<b>Model</b>	<b>Service Bulletin Description</b>	<b>Number</b>
All	Water softeners O-rings Tygon tubing Back flow prevention Contactors SSM water filter parts Serial Number Format Change Ice machine sanitation after a boil order Color and Model Series Change	PS-6-88 PS-9-88 PS-2-89 PS-9-92 PS-1-98 PS-8-98 PS-8-2004 PS-7-2005 PS-6-2006
AC125	Water inlet valve New leg parts	PS-1-89 PS-7-97
AF300	New oil seal New water shed New motor and motor housing	PS-12-2002 PS-15-2003 PS-1-2005
AFE325	New oil seal New water shed New motor and motor housing New compressor	PS-12-2002 PS-15-2003 PS-1-2005 PS-5-2005
AFE400	Drain and water system parts Bin thermostat bracket change TXV change New oil seal New water shed New motor and motor housing New compressor Added hi pressure cut out	PS-11-97 PS-4-2000 PS-13-01 PS-12-2002 PS-15-2003 PS-1-2005 PS-5-2005 PS-1-2006
Bins	Door frames Gasket color change BH260 and BH375 parts BH360 bin SB480 bin BH1100, BH1300, BH1600 bin Ice Express Service Parts Ice Express Cart Service Parts BH801 Service Parts BH1100, 1300, 1600 changes	PS-2-2000 PS-4-2000 PS-14-2000 PS-8-2002 PS-4-2003 PS-6-2003 PS-2-2004 PS-3-2004 PS-10-2004 PS-5-2006

# SERVICE BULLETIN

## **SUB

## Subject: High Pressure Cut Out added to AFE400 air cooled.

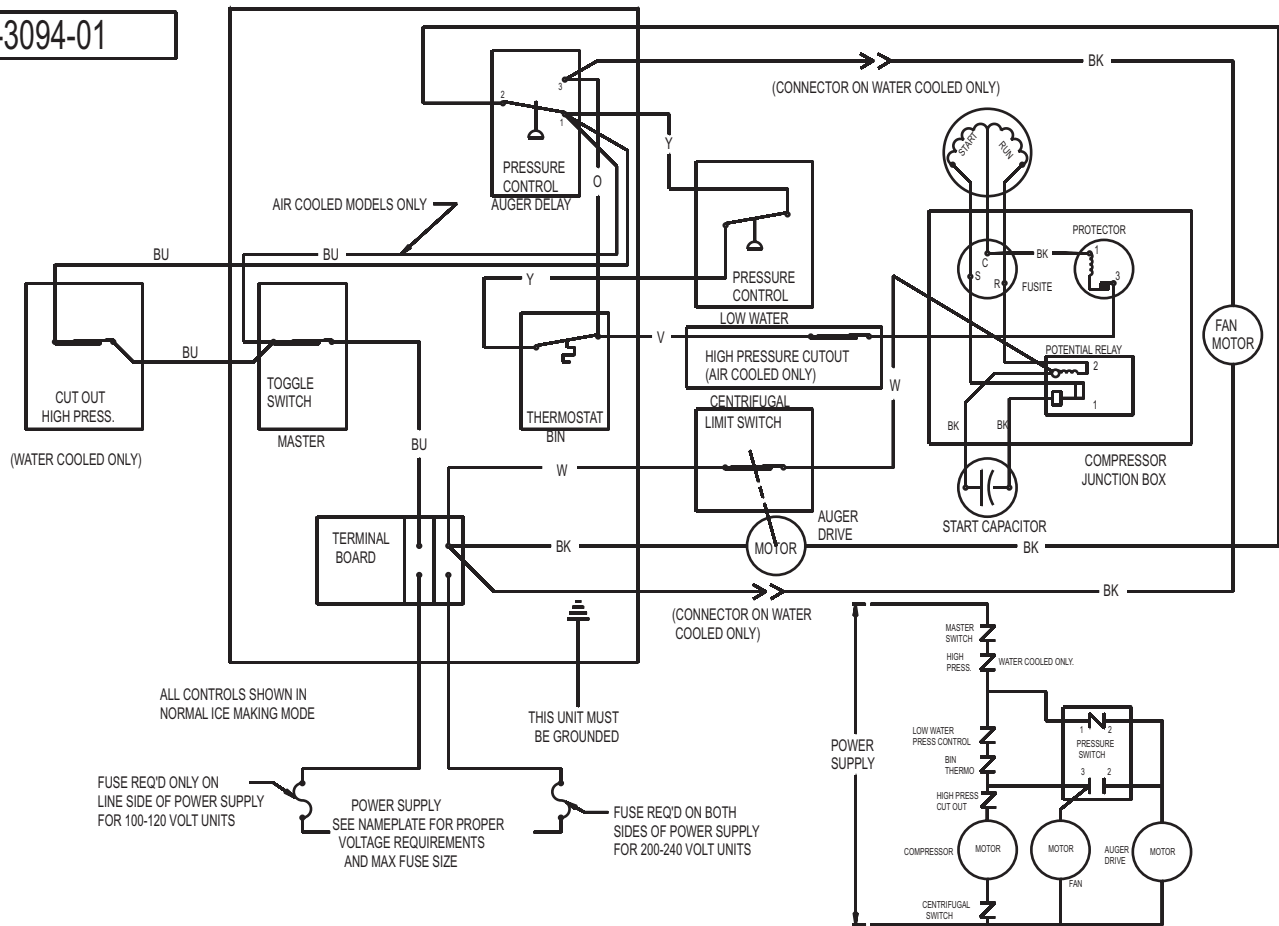
A high pressure cut out switch has been added to the air cooled AFE400. The service part number is 11-0501-24. If the discharge pressure exceeds the cut out pressure setting, the switch will open and shut off the compressor. The switch will automatically reset when the pressure falls to the cut in pressure.

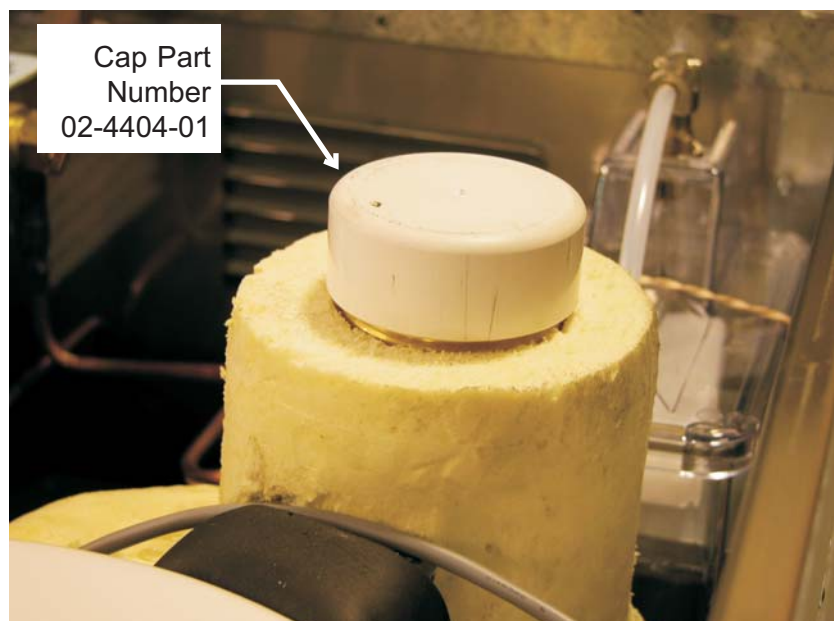
The breaker / bearing retainers for all of the 1/10 HP flakers have changed. The cap hook and cap have been replaced by a sealing cap that covers the entire top of the breaker or bearing retainer. The design change includes new part numbers for the replacement parts:

Prior Number	New Number
AFE400 style	A26706-001	<b>A09413-020</b>
MDT3, MDT4 style	A14678-020	<b>A14591-020</b>
AFE325 style	A26707-001	<b>A15508-020</b>
